CORRECTIVE ACTION PROGRAMS
QUIVIRA MINING COMPANY
AMBROSIA LAKE FACILITY
LICENSE SUA-1473

PREPARED FOR:
NUCLEAR REGULATORY COMMISSION

SEPTEMBER, 1989

QUIVIRA RESPONSES TO NRC AND NMEID QUESTIONS AND COMMENTS

MONITOR WELL 31-01Tra

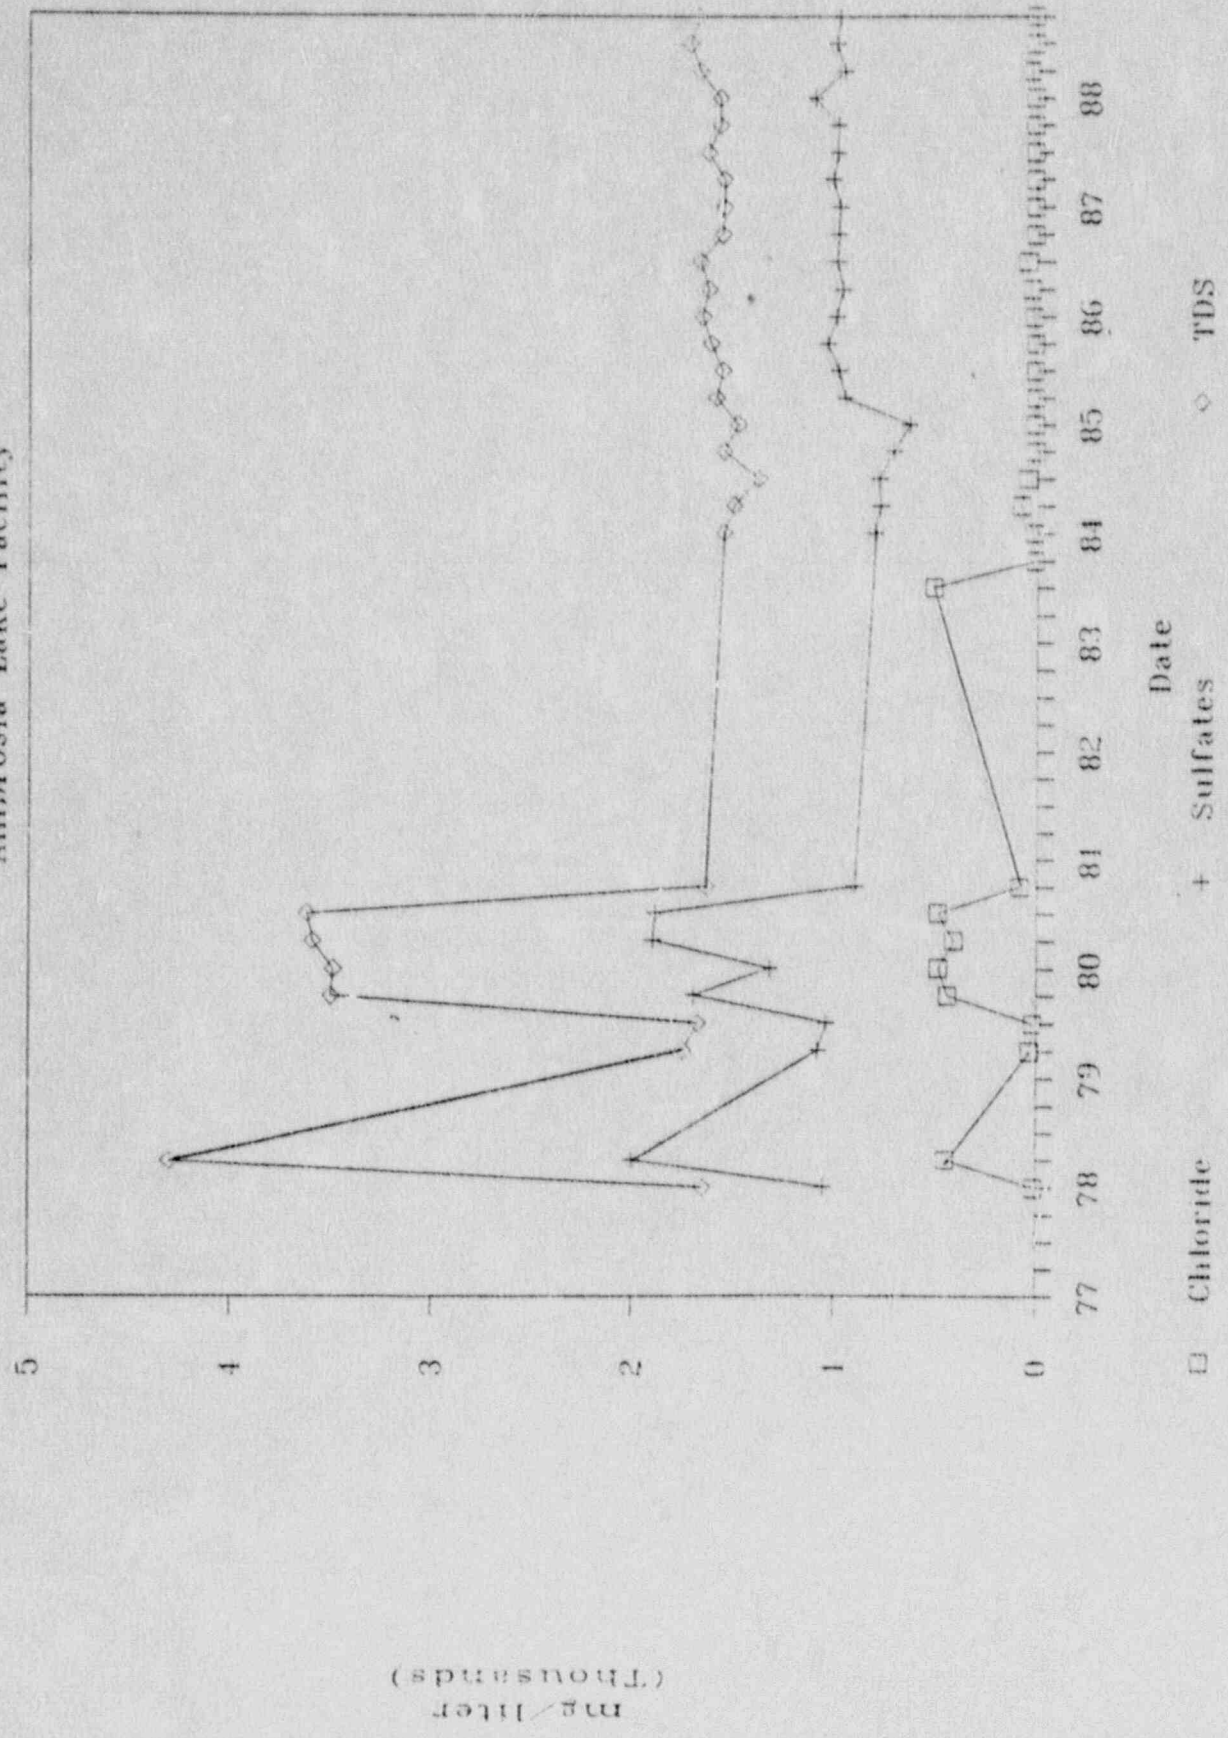
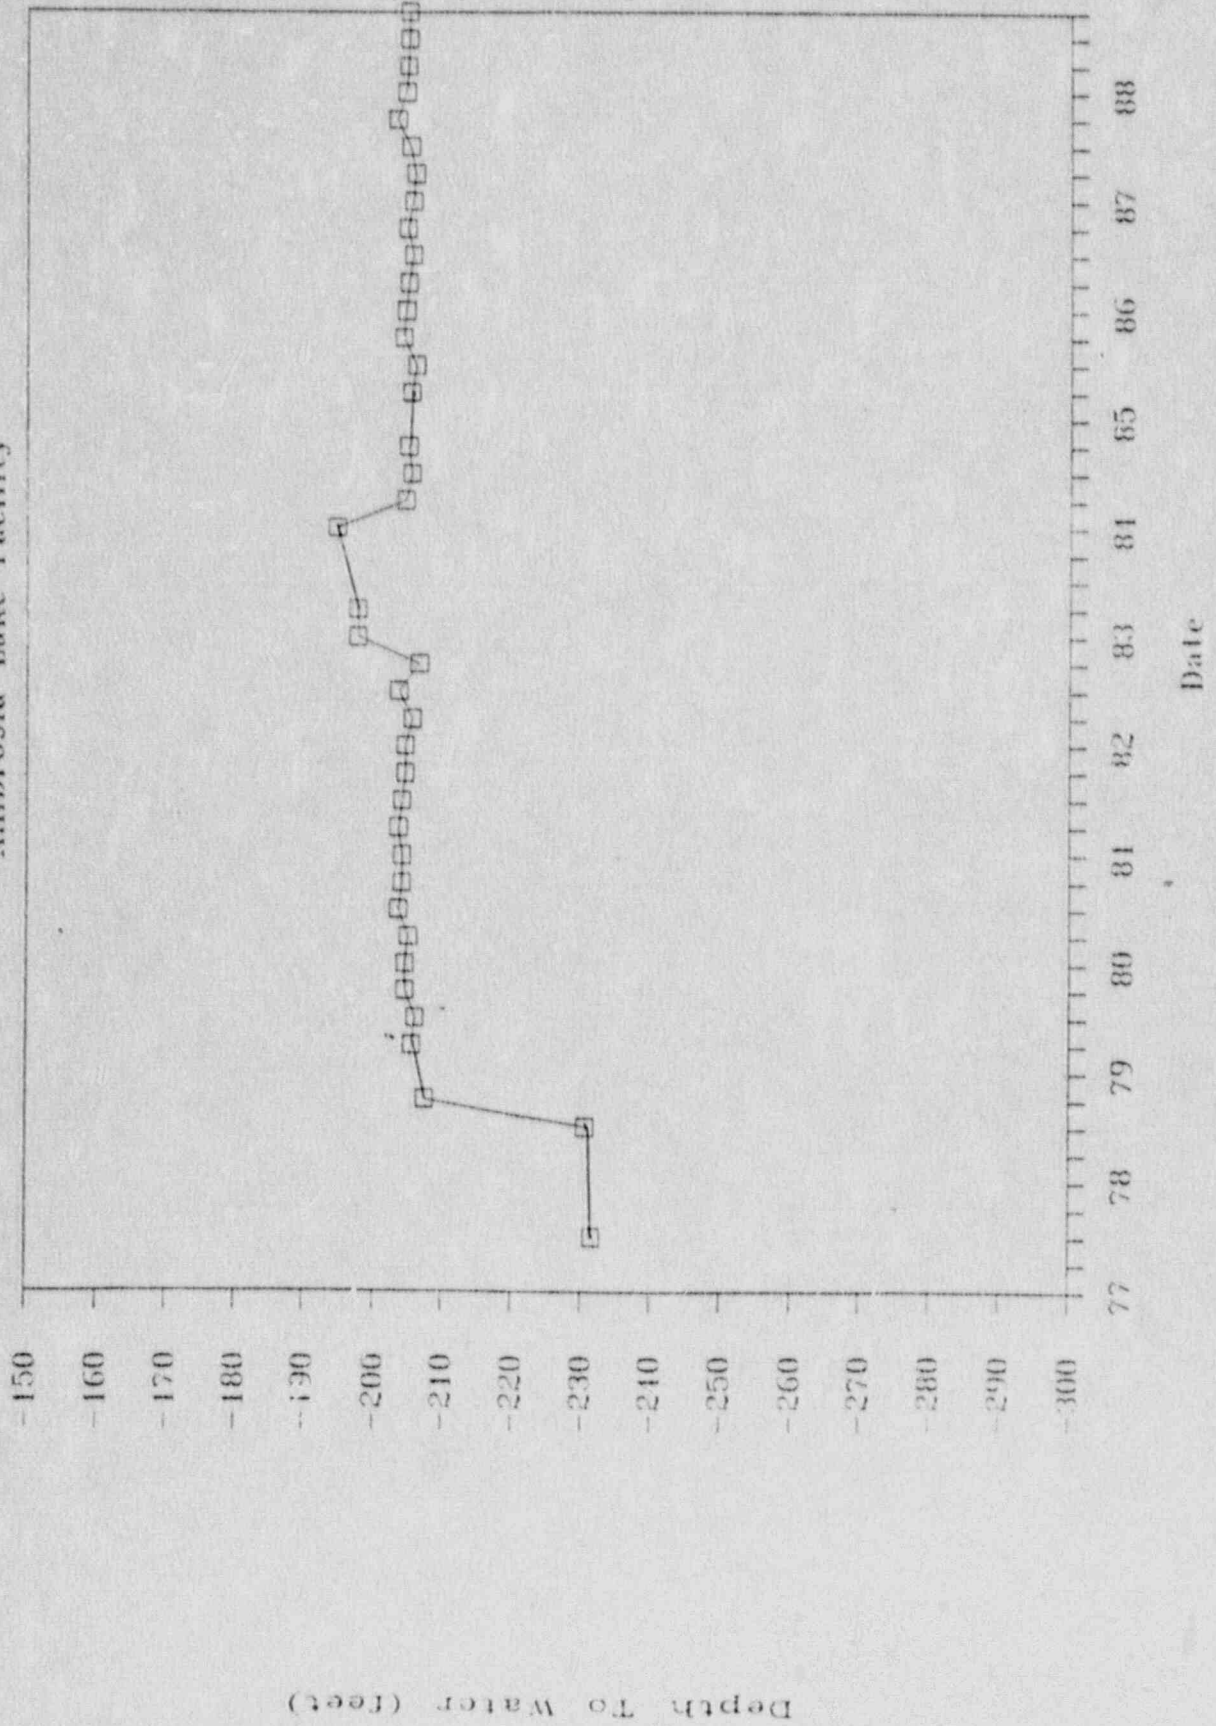
as are the water levels in Tra wells 36-02Tr and 30-01. The EID believes that contamination may be found in the Tra in the vicinity of well 36-02 and in an area just north of Ponds 1 and 2. Whether or not existing contamination is found, new wells in these locations would provide early detection of any future impacts from Pond 2, if used again for tailings solutions.

Attached in Appendix L, the graphs from these two submittals have been combined to show the continuous depth to water measurements and the indicator parameters results. As shown, the depth to water measurements have not varied significantly during the last 5 years nor have the indicator parameters sulfates, chlorides, and TDS.

Quivira also questions statement that water levels within 31-01Tra and 30-01 monitor wells are below the base of the Tres Hermanos A sandstone. As indicated on the lithologic logs of 31-01Tra and 30-01, the historical depth to water data as presented in Appendix M, indicates water levels are approximately 5 feet and 25 feet above the base of the Tres Hermanos A sandstone/shale contact respectively.
